Access Compliance Report

Public Rights-of-Way

Intersection ID: N/A	Main Street: ASCENSION_WY	Cross Street: INNOVATION_DR	Location: SW
ADA ID: 4B1760BEC2D8	Ramp Type: Perp	Initial Pass/Fail: Fail	Overall Compliance: No
		Severity Score: 12.5

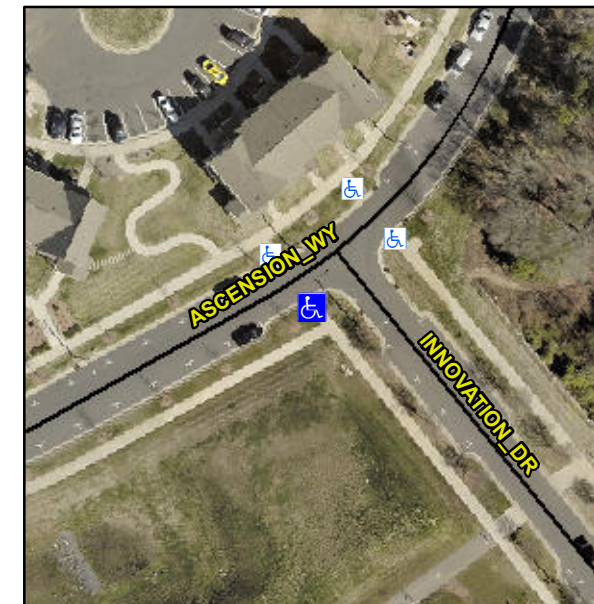
R304.2.2

Compliance	Description	Data	Compliance	Description	Data
N/A	Ramp Length (in)	71.0	No	Ramp Slope (%)	8.8
Yes	Ramp Width (in)	72.0	Yes	Ramp XSlope (%)	0.4
N/A	Flare Type LT	N/A	N/A	Flare Type RT	N/A
N/A	Flare Slope LT (%)	N/A	N/A	Flare Slope RT (%)	N/A
N/A	Flare Traversable LT?	N/A	N/A	Flare Traversable RT?	N/A
N/A	Landing Length (in)	N/A	N/A	DWS Provided?	N/A
N/A	Landing Width (in)	N/A	N/A	DWS Contrast?	N/A
N/A	Landing Slope (%)	N/A	N/A	DWS Length (in)	N/A
N/A	Landing X Slope (%)	N/A	N/A	DWS Full Width?	N/A
N/A	Landing Curb? (Y/N)	N/A	N/A	DWS Offset (in)	N/A
N/A	Shared Landing?	N/A			
N/A	Gutter Ponding?	N/A	N/A	Gutter Slope (%)	N/A
N/A	Gutter Lip Ht (in)	N/A	N/A	Gutter X Slope (%)	N/A
N/A	Painted X Walk1?	No	N/A	Painted X Walk2?	N/A
	X Walk 1 Direction	To NW		X Walk 2 Direction	N/A
N/A	X Walk 1 Width (in)	N/A	N/A	X Walk 2 Width (in)	N/A
	X Walk 1 Slope (%)	1.0		X Walk 2 Slope (%)	N/A
	X Walk 1 X Slope (%)	4.0		X Walk 2 X Slope (%)	N/A

Remove & Replace Entire Ramp.
